Access Compliance Report

Public Rights-of-Way

Intersection ID: 13301	Main Street: S_TRYON_ST	Cross Street: W_CATHERINE_ST	Location: NW
ADA ID: 370CF3E54E10	Ramp Type: BlendTrans2	Initial Pass/Fail: Fail	Overall Compliance: No
Codes/Mitigation Info/Possible Solution		Field Measurements/Component Compliance	
Severity Score: 17.5

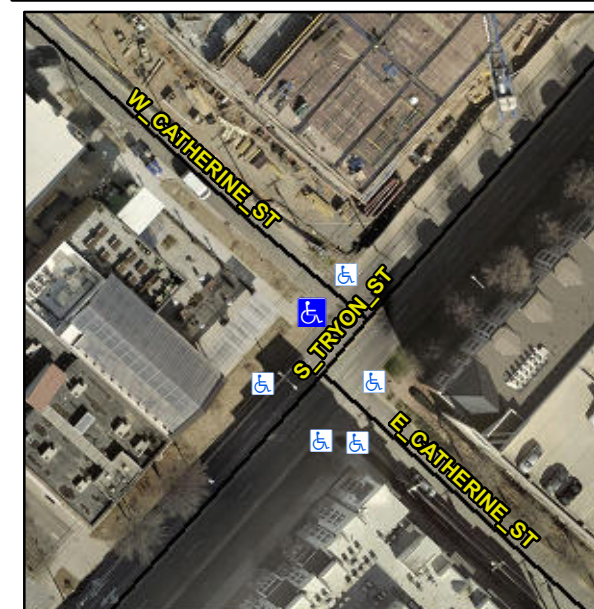
Not Found, R304.5.1

Compliance	Description	Data	Compliance	Description	Data
N/A	Ramp Length (in)	57.0	Yes	BlendTrans Slope (%)	2.3
No	Ramp Width (in)	33.0	Yes	BlendTrans XSlope (%)	1.2
N/A	Flare Type LT	N/A	N/A	Flare Type RT	N/A
N/A	Flare Slope LT (%)	N/A	N/A	Flare Slope RT (%)	N/A
N/A	Flare Traversable LT?	N/A	N/A	Flare Traversable RT?	N/A
N/A	Landing Length (in)	N/A	N/A	DWS Provided?	N/A
N/A	Landing Width (in)	N/A	N/A	DWS Contrast?	N/A
N/A	Landing Slope (%)	N/A	N/A	DWS Length (in)	N/A
N/A	Landing X Slope (%)	N/A	N/A	DWS Full Width?	N/A
N/A	Landing Curb? (Y/N)	N/A	N/A	DWS Offset (in)	N/A
N/A	Shared Landing?	N/A			
N/A	Gutter Ponding?	N/A	N/A	Gutter Slope (%)	N/A
N/A	Gutter Lip Ht (in)	N/A	N/A	Gutter X Slope (%)	N/A
N/A	Painted X Walk1?	No	N/A	Painted X Walk2?	No
	X Walk 1 Direction	To SE		X Walk 2 Direction	To NE
	X Walk 1 Width (in)	N/A		X Walk 2 Width (in)	N/A
	X Walk 1 Slope (%)	5.0		X Walk 2 Slope (%)	4.9
	X Walk 1 X Slope (%)	2.4		X Walk 2 X Slope (%)	1.1

N/A	Ramp inside XWalk1?	N/A	N/A	Ramp inside XWalk2?	N/A
	Road Slope (%)	5.0		Clear Space?	N/A
	Road X Slope (%)	1.9	N/A	Clear Space to XWalk (in)	N/A
N/A	Any Obstructions?	N/A	N/A	Storm Grate/Utility Hazard?	N/A
	Obstruction Type			Storm Grate/Utility Type	
		N/A			N/A
			Yes	Surface Condition? (G/P)	Good
			No	Curb Slope (%)	6.1

Remove & Replace Curb Ramp With Two New Directional Ramps or Equivalent.
